Errata for FM20L08

Errata Number	003c (applies to Date Codes up to 0605)
Date	Feb. 15, 2006
Product	1Mbit FRAM, 128Kx8
Product Marking	FM20L08-60-TG (extended temperature)

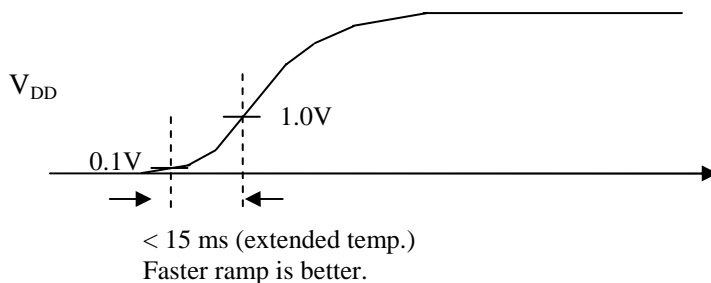
- 1) If the V_{DD} power-up ramp is too slow, the chip will not function properly. V_{DD} must transition faster than 15 ms from 0.1V to 1.0V. See diagram below.
